# **Nomad**

## SERVICE BULLETIN

### TRANSMITTAL LETTER FOR SERVICE BULLETIN ANMD-55-31 REV 1

### STABILISERS - HORIZONTAL STABILISER - CONTROL ROD TRUNNION GAP - INSPECTION AND REPAIR

Figure 1 Horizontal Stabiliser Mass Balance Arm (Sht 1 of 2)

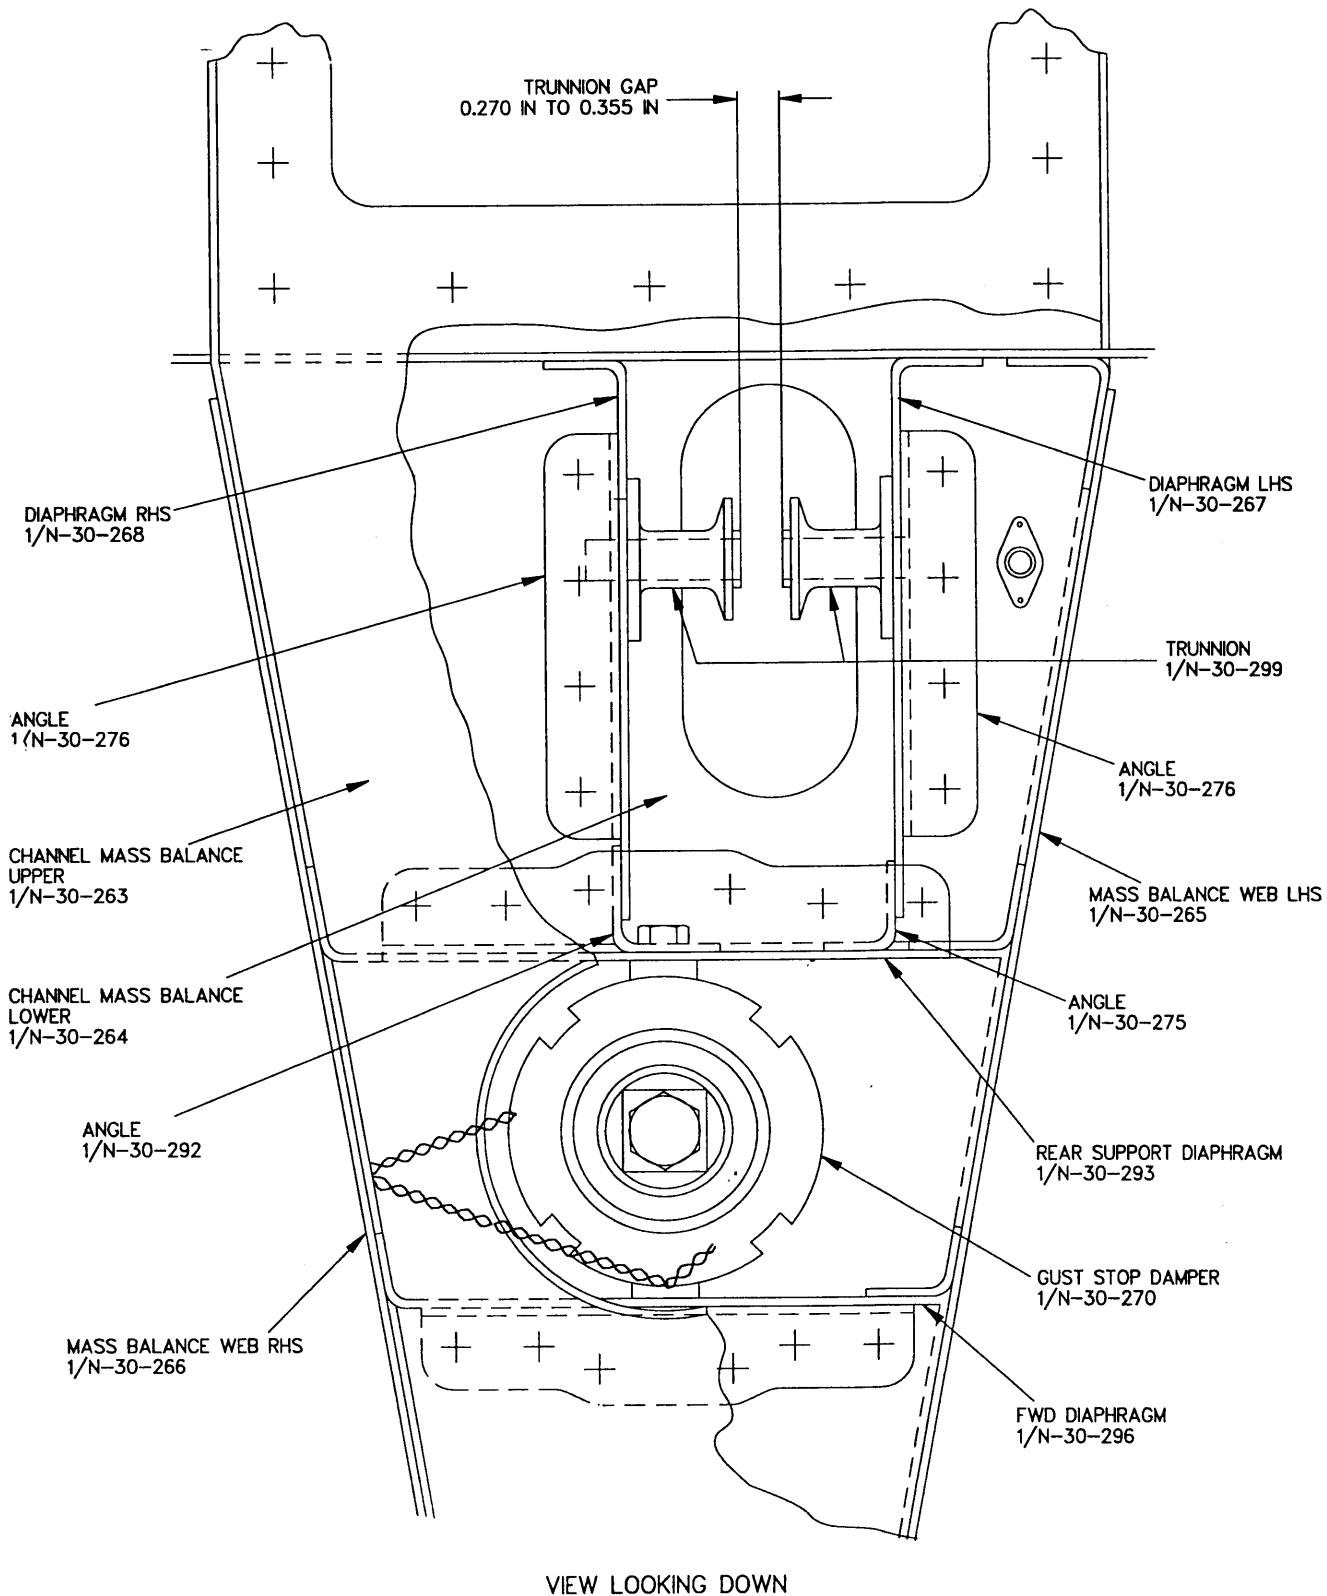
- (10) Remove the mass balance block from the mass balance. Mark the front and upper surfaces to assist in correct assembly.
- (11) Derivet and identify upper mass balance channel PN 1/N-30-263 (Ref Fig 1 Sht 1).
- (12) Remove the three forward gust damper mounting bolts and countersunk washers and retain for later reinstallation.

- (13) Derivet LHS mass balance web PN 1/N-30-265 (Ref Fig 1 Sht 1).

This is required to gain access to the LHS trunnion diaphragm PN 1/N-30-267 (Ref Fig 1 Sht 1). Do not remove the last row (closest to spar) of rivets attaching the LHS mass balance web (Ref Fig 1 Sht 2 NOTE).

- (14) Derivet gust stop damper rear support diaphragm PN 1/N-30-293 (Ref Fig 1 Sht 1).
- (15) Derivet lower and aft ends of both trunnion diaphragms PN 1/N-30-267 LH and 1/N-30-268 RH and forward damper support diaphragm PN 1/N-30-296 (Ref Fig 1 Sht 1).
- (16) Remove diaphragms and damper from the mass balance arm and on a work bench, remove the gust stop damper PN 1/N-30-270 (Ref Fig 1 Sht 1).
- (17) On a work bench derivet trunnion diaphragms from angles PN 1/N-30-292 and 1/N-30-275. Scrap trunnion diaphragms.

- (18) Temporarily reinstall damper rear support diaphragm PN 1/N-30-293 (Ref Fig 1 Sht 1) and using skin pins repin the LHS mass balance web.
- (19) Refit Jig PN 1630-3510 without the use of the supplied trunnion pin.
- (20) Install to jig a new trunnion block PN 1/N-30-299 on RHS (Ref Fig 1 Sht 1) using the locally manufactured trunnion pin (Ref Fig 5).
- (21) Install the new trunnion diaphragm (RHS) PN 1/N-30-268 and then clamp, ensuring a flush fit with the horizontal stabiliser spar, the lower mass balance channel and trunnion.

The correct and careful placement of the new diaphragms and trunnions is the key to ensure an acceptable trunnion gap at the conclusion of this repair. Any forcing and/or distortion during assembly of parts will cause undesirable gaps and stresses after rivetting (Ref Fig 1 Sht 1).

Figure 1 Horizontal Stabiliser Mass Balance Arm (Sht 2 of 2)

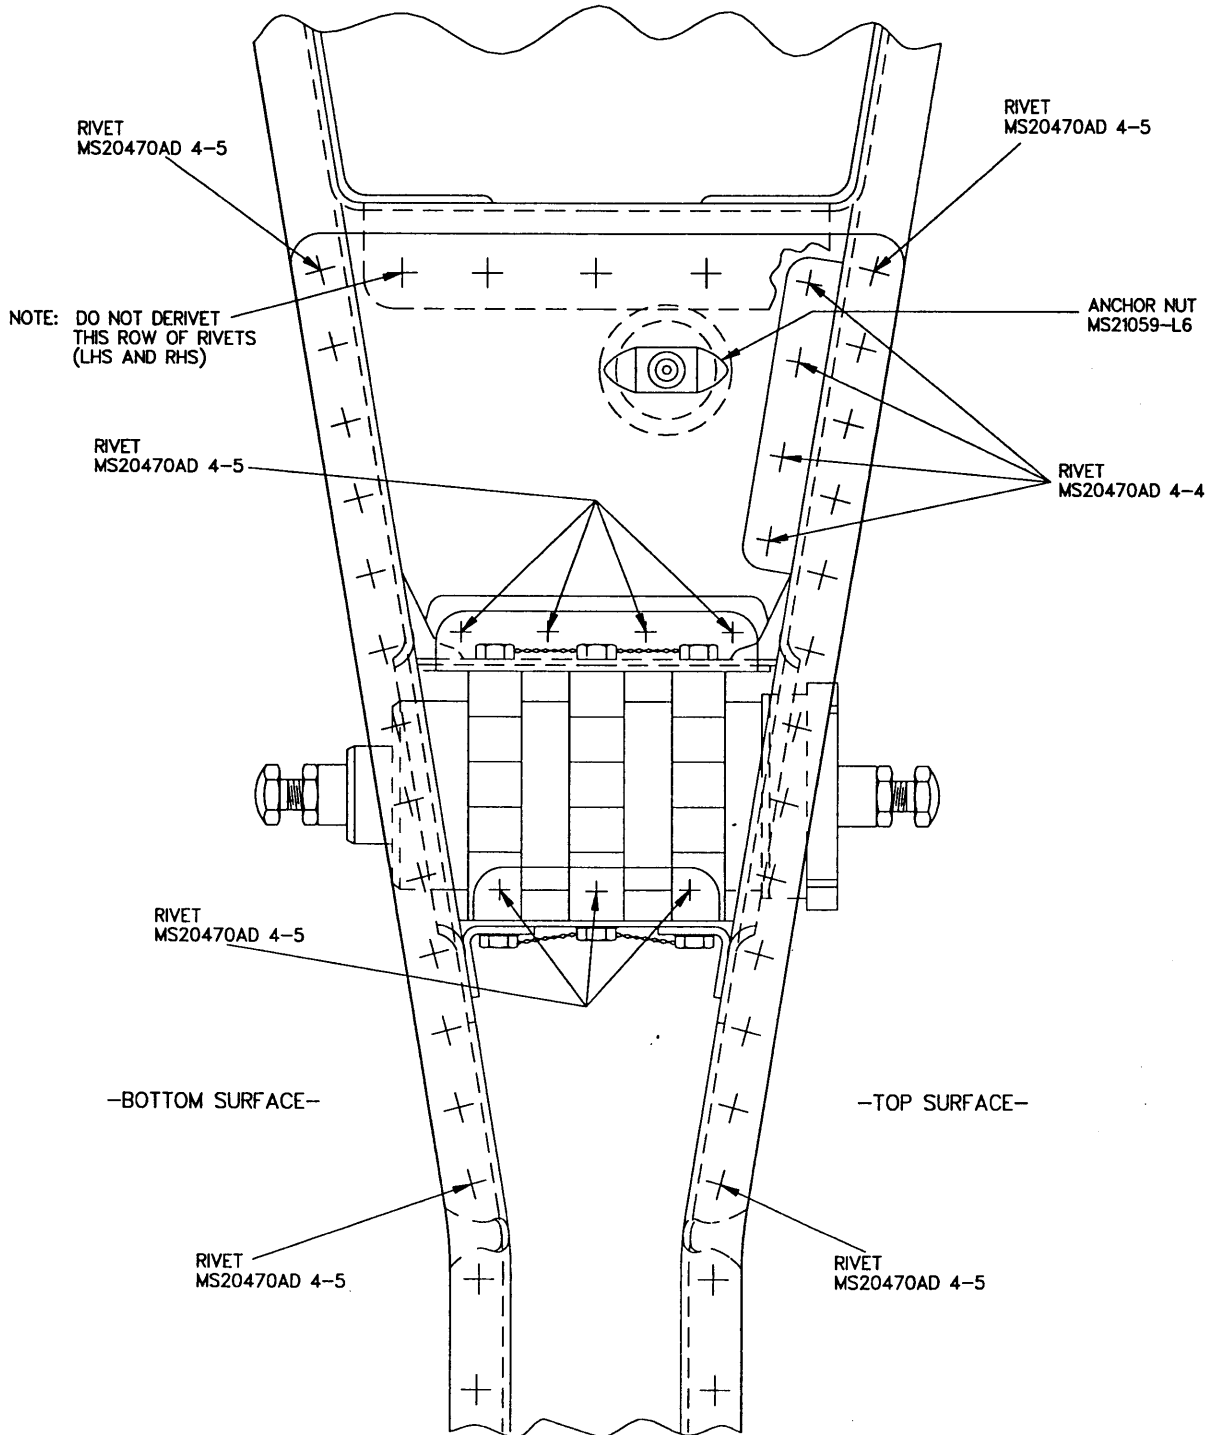
Do not remove the last row (closest to spar) of rivets attaching the RHS mass balance web (Ref NOTE on Fig 1 Sht 2).

Figure 2 Trunnion

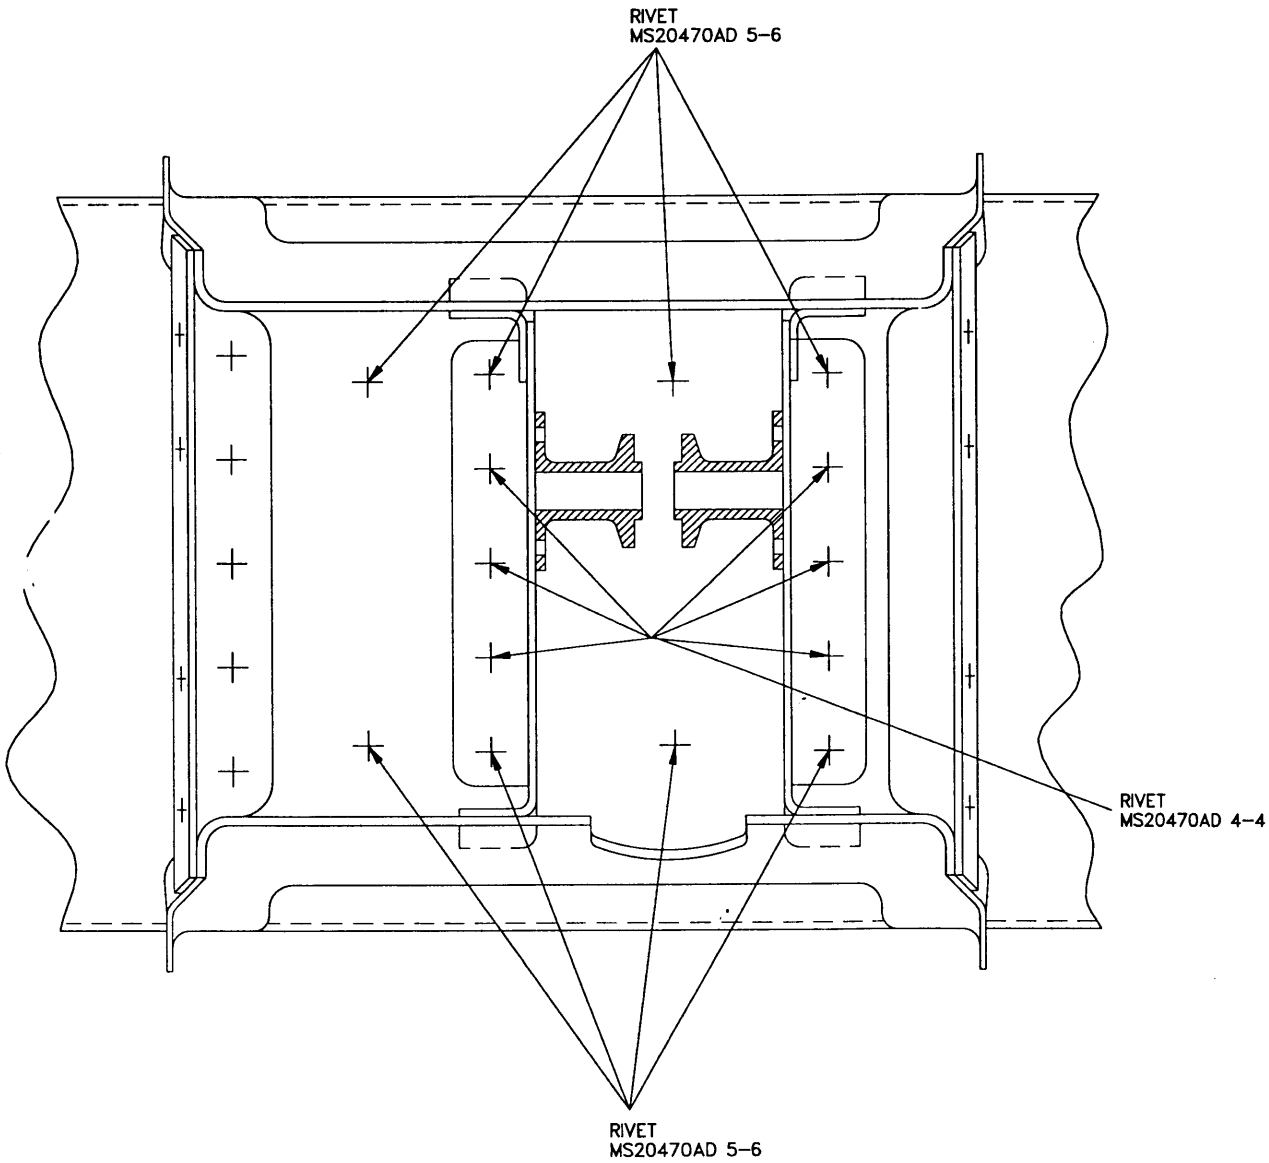
- If solid rivets cannot be fitted as shown in Figures 1 and 2, then alternative Cherrymax rivets may be used at the locations shown in Figures 3 and 4.

Solid rivets are preferred (Ref Fig 1 and 2) however, alternative Cherrymax rivets (Ref Fig 3 and 4) may be used where access is difficult.

Figure 5 Trunnion Pin Manufacture

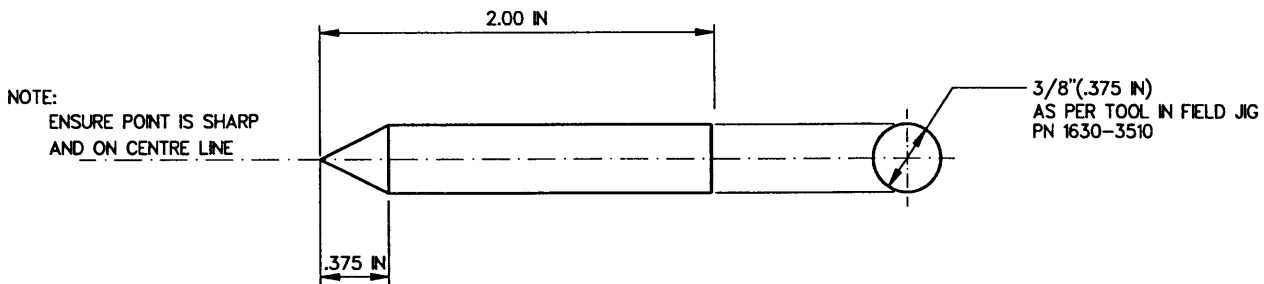
- (24) Using the locally manufactured trunnion pin (Ref Fig 5) and ensuring it has a sharp point, insert the pin through Jig PN 1630-3510 and trunnion and with a slight tap centre mark the RHS diaphragm installed in step 23.

Figure 6 Drill Plate Manufacture

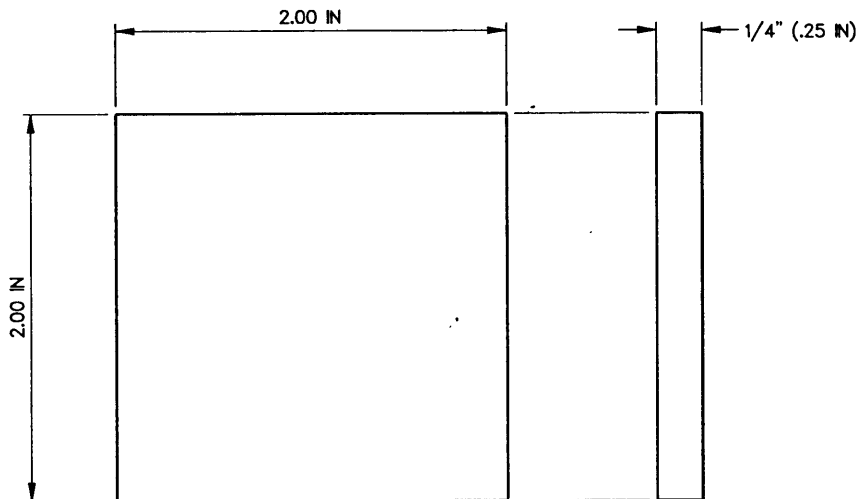
- (25) Remove the trunnion pin and diaphragm and drill a 0.375 (3/8) in hole at the marked location.
- (26) With the other locally manufactured tool (Ref Fig 6) drill plate, and the old RHS diaphragm removed in step 15, backdrill the trunnion periphery rivet holes into the tool.
